Board of Adjustment Called Special Session

1. Consideration, discussion, and possible action on a variance request from Manor Code of Ordinances, Chapter 15, Article 15.02. Section 15.02.005(a) Queuing Requirements and located on Lot 7B, Block A, Manor Commons SW Commercial, Manor, TX to permit vehicle queuing within a fire lane.

Re: Bank of America – Manor Commons SWC Hwy 290 & FM 973 Job No: 20.0003779.000

Alternative Methods of Compliance (AMOC)

- AMOC Request
 - o AMCO item 1 Turn radius
 - o AMOC item 2 does not apply to fire code and was not reviewed
- Provided site plan, pg C3.0

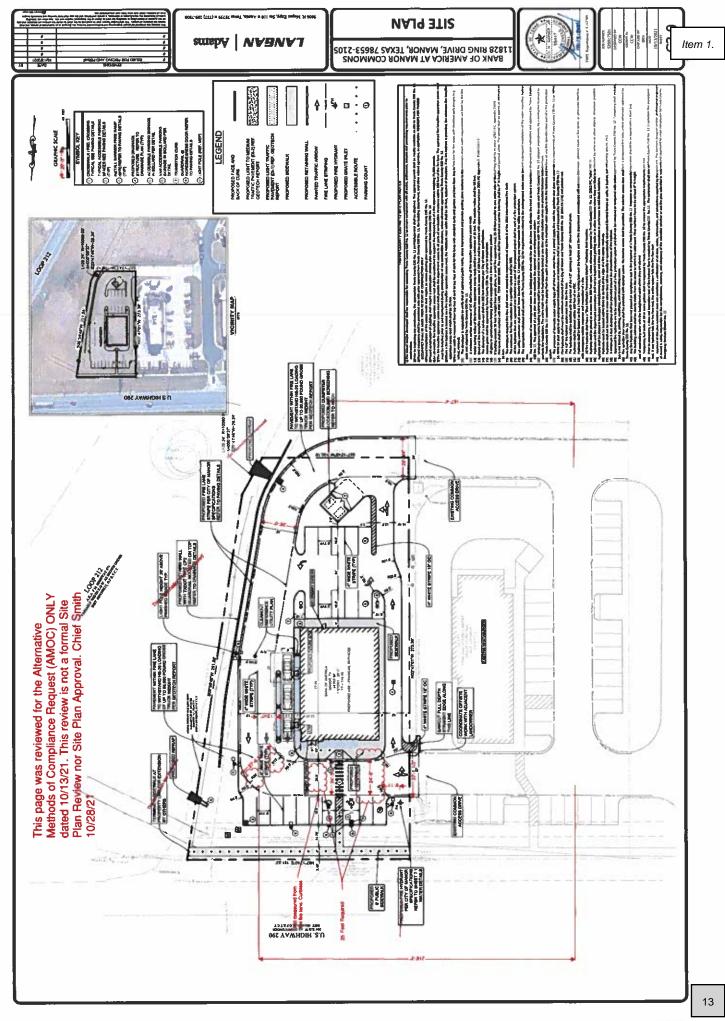
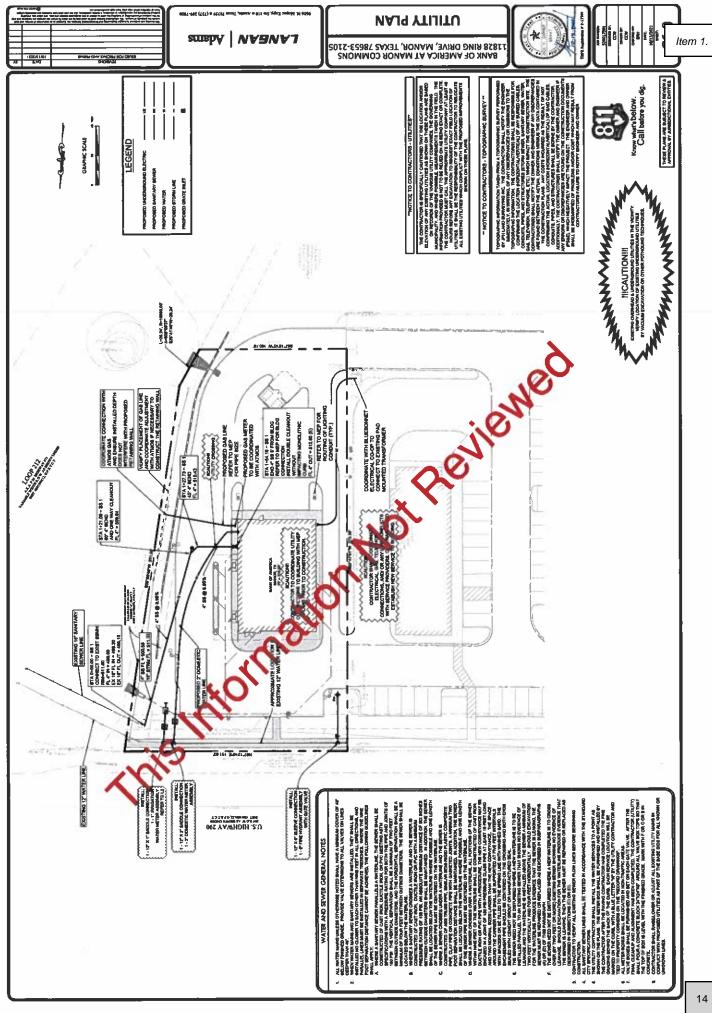
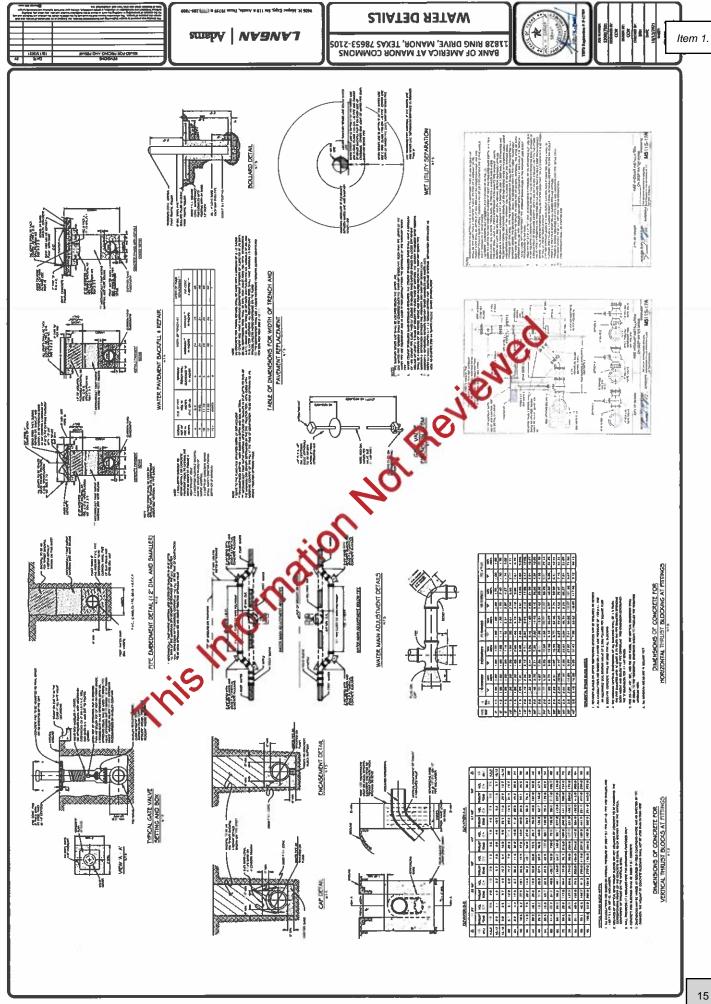
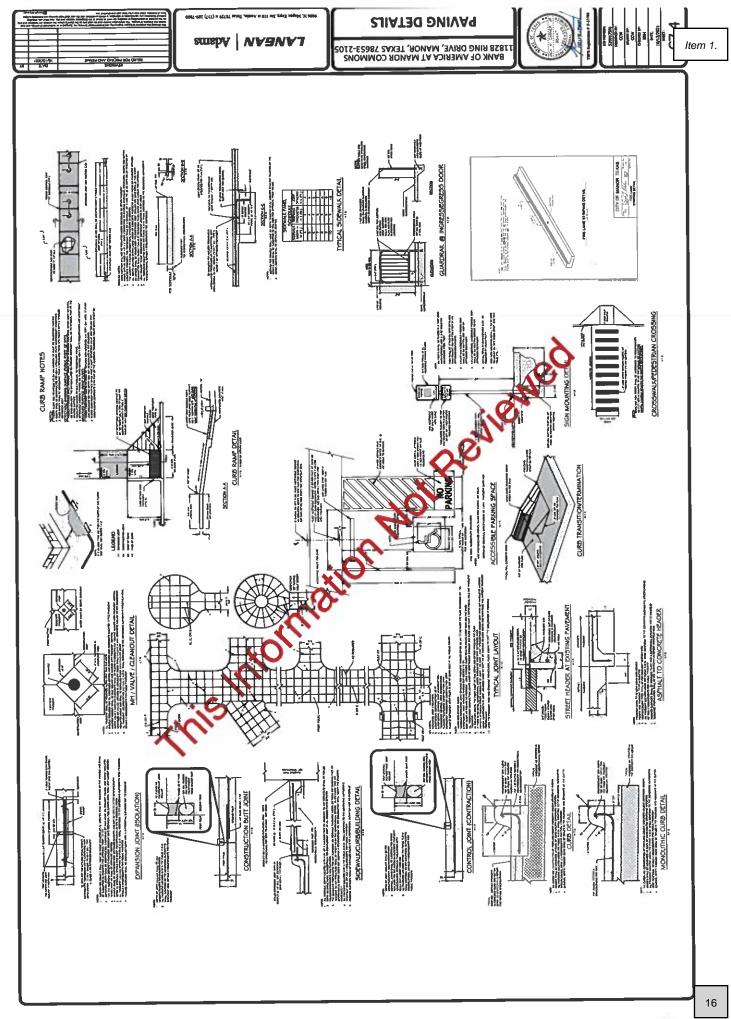
However, we did note that the fire lane width in front of the building is less than the 25 feet as required by code.

• Correct fire lane widths for site plan review.

We have found that your AMOC #1 request meets an alternative requirement of the local code adoptions and amendments and is approved.
